Access Compliance Report Public Rights-of-Way (Curb Ramps)

Main Street: CLAYMONT_DR	Cross Street: LAURELHURST_ST	Location: E
--------------------------	------------------------------	-------------

ADA ID: RPRK211020175557	Ramp Type: Type 4 - Parallel	Initial Pass/Fail: Fail	Overall Compliance: No	Severity Score: 2
--------------------------	------------------------------	-------------------------	------------------------	-------------------

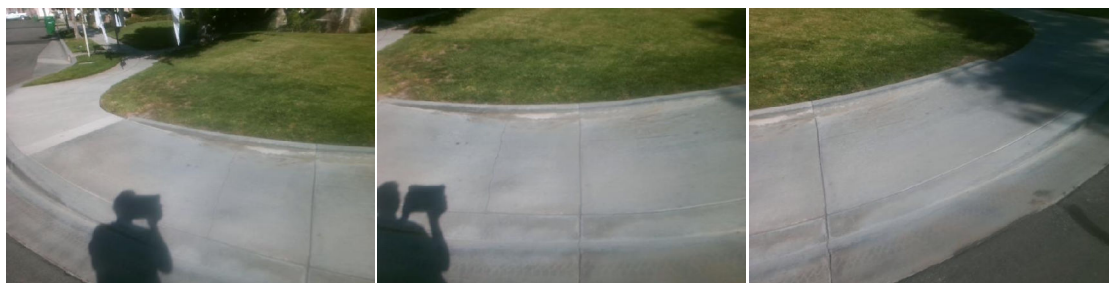
Compliance	Description	Data	Compliance	Description	Data
N/A	Ramp Length LT (in)	113	N/A	Ramp Length RT (in)	111
Yes	Ramp Width LT (in)	53	Yes	Ramp Width RT (in)	53
Yes	Ramp Run Slope LT (%)	2.9	Yes	Ramp Run Slope RT (%)	6.3
No	Ramp Cross Slope LT (%)	2.6	No	Ramp Cross Slope RT (%)	2.8
N/A	Landing Present	N/A	N/A	DWS Provided	N/A
N/A	Landing Length (in)	N/A	N/A	DWS Contrast	N/A
N/A	Landing Width (in)	N/A	N/A	DWS Length (in)	N/A
N/A	Landing Run Slope (%)	N/A	N/A	DWS Full Width	N/A
N/A	Landing Cross Slope (%)	N/A		DWS Offset Type	N/A
N/A	Landing Movement Obstructed?	N/A	N/A	DWS Offset Left (in)	N/A
	Landing Movement Type	N/A	N/A	DWS Offset Right (in)	N/A
N/A	Landing Shared	N/A			
N/A	Clear Space	Yes			
N/A	Clear Space To Crosswalk (in)	N/A			
N/A	Marked Crosswalk 1	No	N/A	Marked Crosswalk 2	No
	Crossing 1 Direction	NW		Crossing 2 Direction	SW
N/A	Marked Crosswalk 1 Width (in)	N/A		Marked Crosswalk 2 Width (in)	N/A

Remove & Replace Curb Ramp With Two New Directional Ramps or Equivalent.
